Product Change Notification - SYST-22DREG067

Date: 22 May 2010

Notification subject: ERRATA - PIC16F631/677/685/687/689/690 Family Silicon Errata and Data Sheet Clarification

PIC16F631/677/685/687/689/690 Family Silicon Errata and Data Sheet Clarification

FIGURE 8-2: COMPARATOR C1 SIMPLIFIED BLOCK DIAGRAM

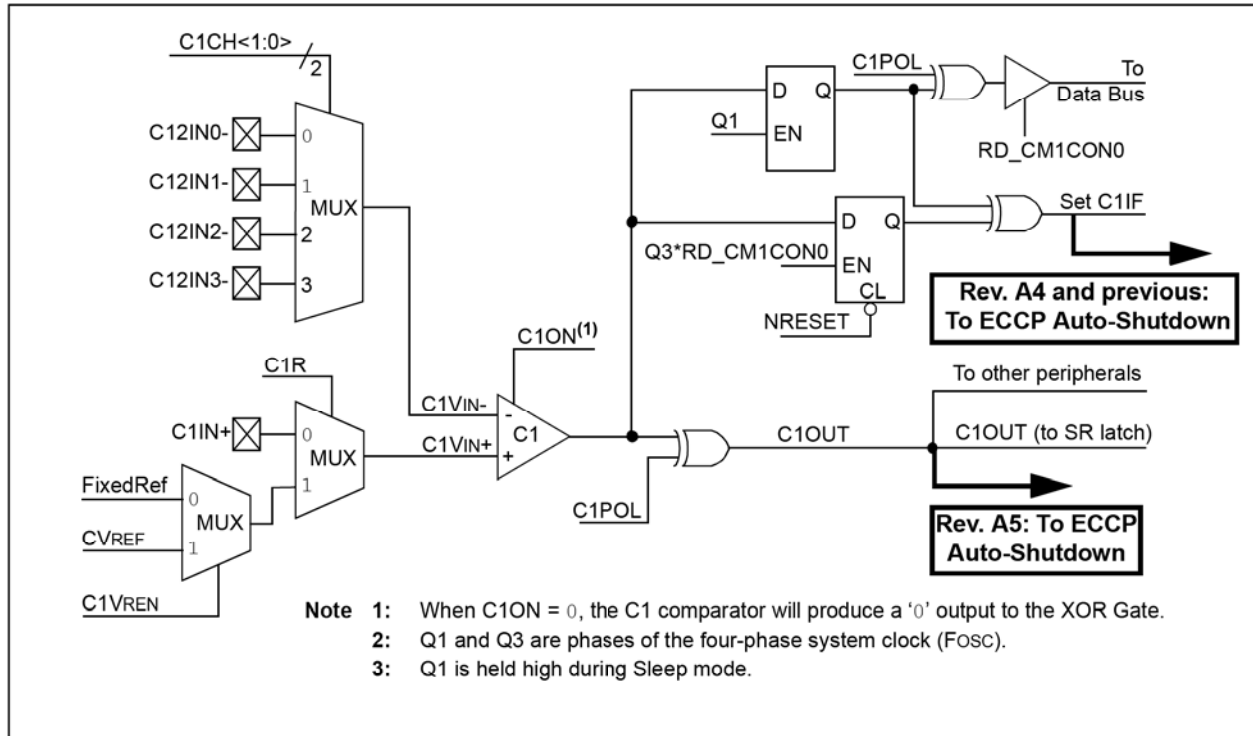
The PIC16F631/677/685/687/689/690 Rev. A4 silicon for the ECCP auto-shutdown is connected to the C1IF and C2IF flags. See Figures 8-2 and 8-3 on the following page.

The auto-shutdown connection (Rev. A4 and previous) to C1IF and C2IF causes the auto-shutdown to incorrectly operate synchronously. Additionally, reads of CMxCON0 will incorrectly clear an auto-shutdown event.

- 1) Poll the CxOUT bit until it is low.
- 2) Read CMxCON0 to precondition CxIF.
- 3) If CMxCON0 is read while CxOUT is changing, repeat steps 1 and 2.
